Addendum No. 2

Water Main Replacement Project for F St. & 16th St., Sparks, NV

PWP Bid No. WA-2016-181
June 8, 2016

D2

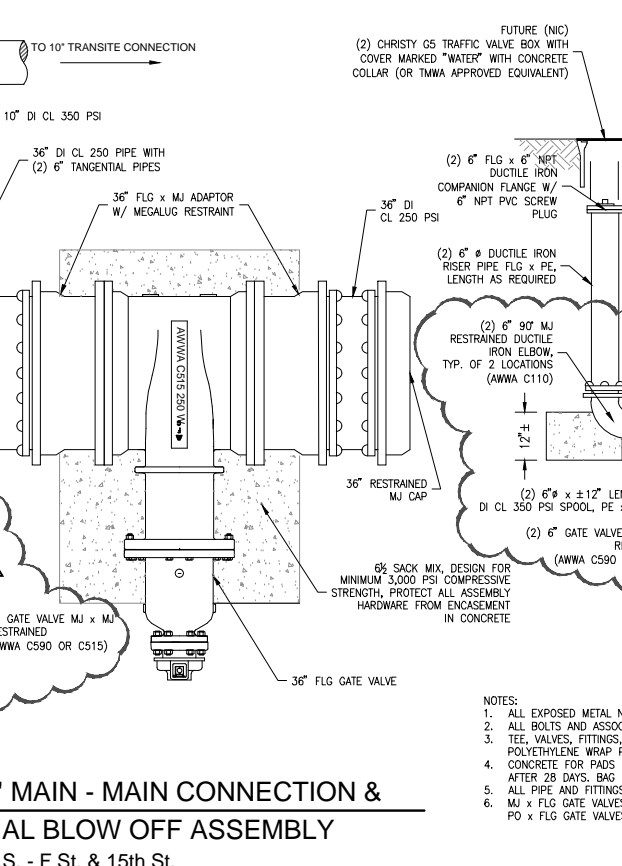
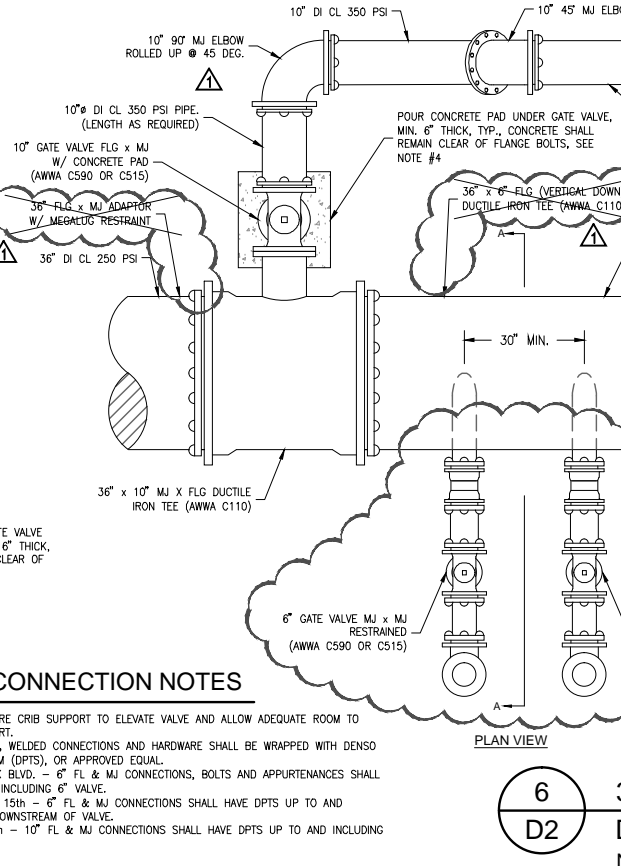
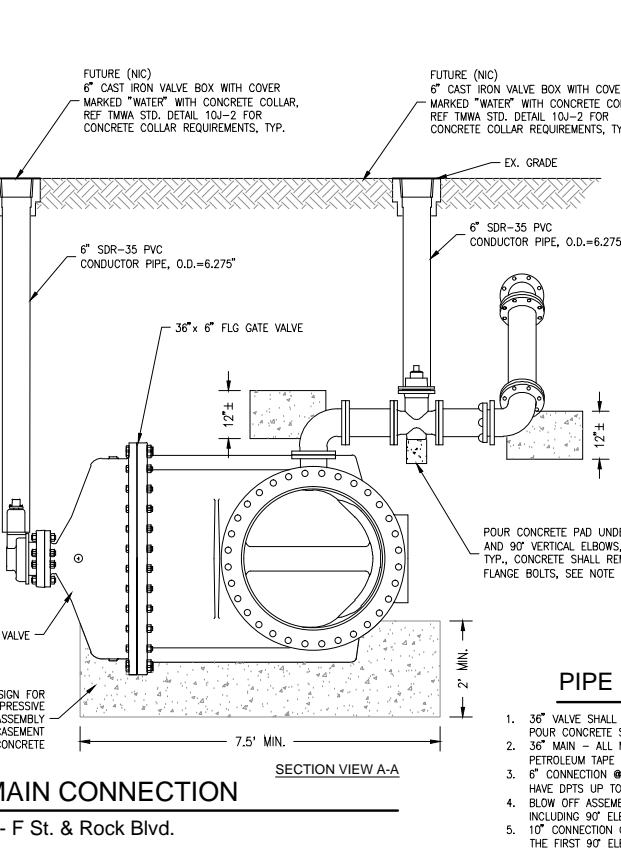
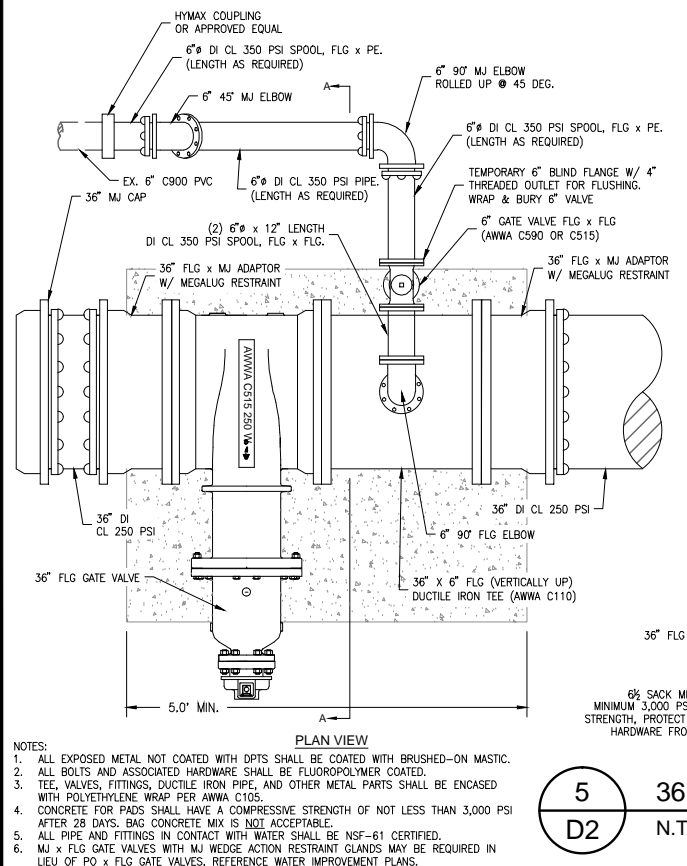
1. Drawing sheet D2 - Details; Detail 6/D2; Due to product availability, deletion of FL connection fittings for two (2) six inch tangential pipes and replaced with MJ connection fittings as indicated by revision cloud and labeled as "delta 2" in the revision table. Replace sheet D2 with the attached revised D2 sheet in its entirety.

REVISION	DESCRIPTION	BY	APP	DATE
1	REVISED DETAIL 6 -- ADDENDA 1	RA		6/2/16
2	REVISED DETAIL 6 -- ADDENDA 2	RA		6/8/16
